**CERTIFICATE OF APPROPRIATENESS**

**Property:** 1512 South Blvd, Lot 2, Block 4, Edgemont Subdivision in Boulevard Oaks Historic District, 6,824sq ft two-story single-family residence with detached guest quarters. situated on a **21,784** square foot (116.75 'x 186.5') corner lot

**Proposal:** Alteration – Addition

- *Revision to COA approved by director only January 2022 under HP2022\_0012*
- *HAHC July 29,2021 under HP2021\_0174 for to update front entrance openings and added awning on pool house – see updated drawing set, drawings for historic primary residence remains as submitted in HP2021\_0174*
- *Drawing/Lite pattern of windows looks altered from original dimensions – applicant states it is due to more specific, updated measurements.*

PROPOSED WEST ELEVATION

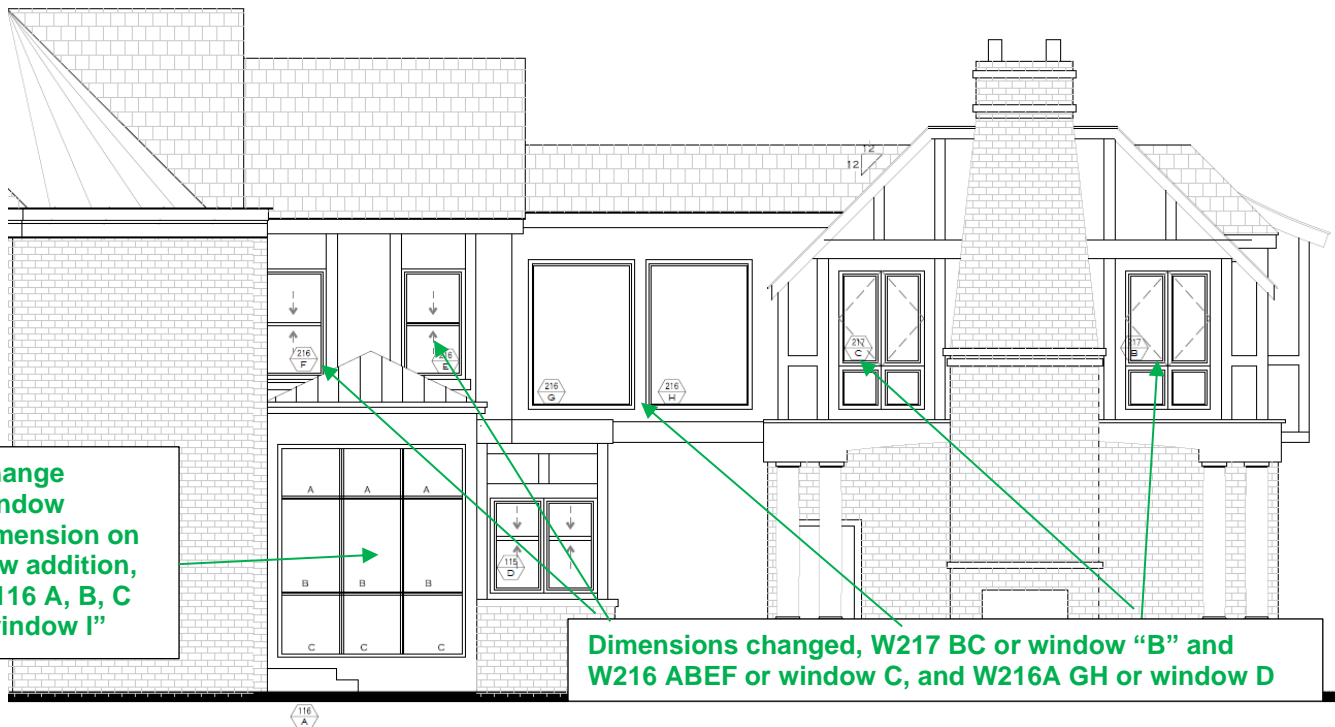
Dimensions changed, 221 A or window "E"

Change window dimension on new addition, 115 A, B, C, D or "window F"

Change window dimension on new addition, W116 A, B, C "window I"

**PROPOSED EAST ELEVATION (INTERIOR PROPERTY LINE – not seen from street)**

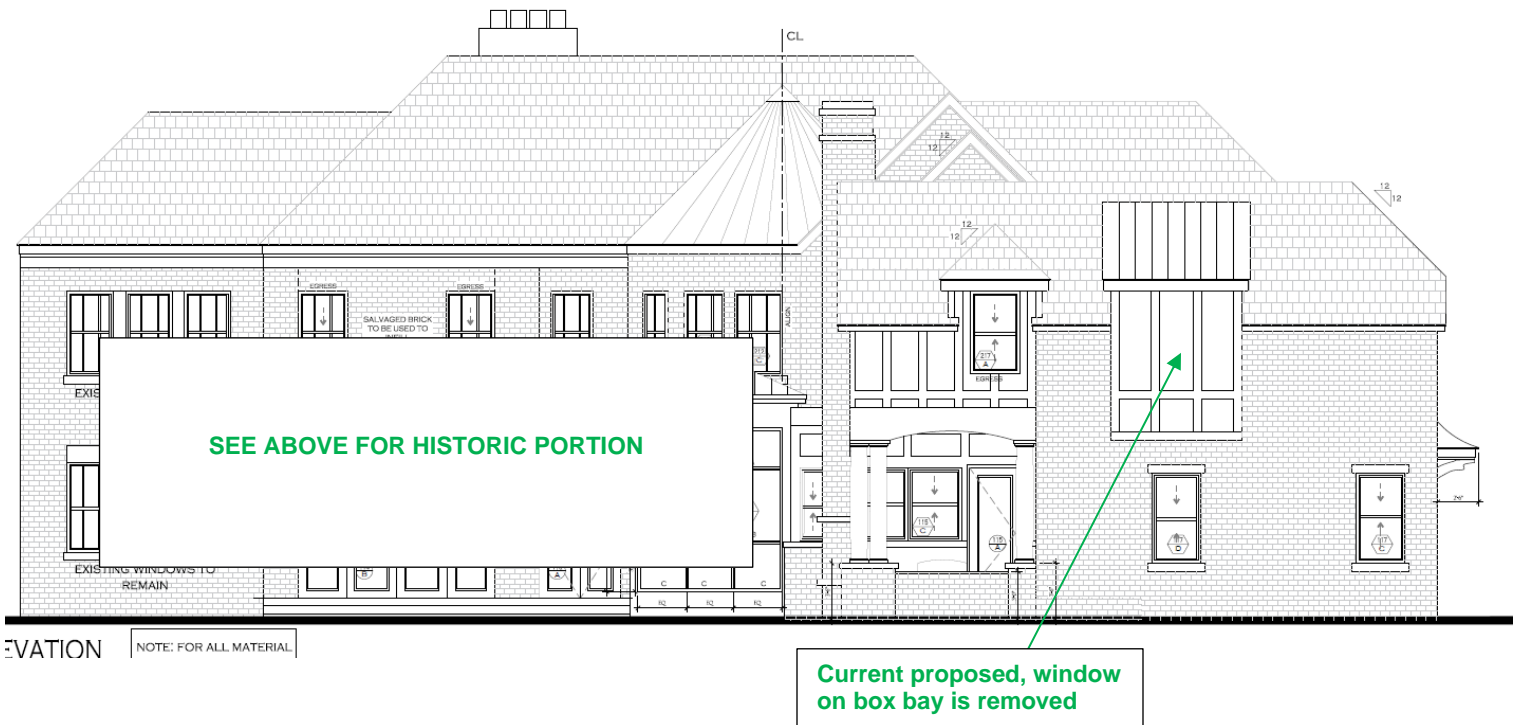
Dimensions changed, W217 BC or window "B" and W216 ABEF or window C, and W216A GH or window D
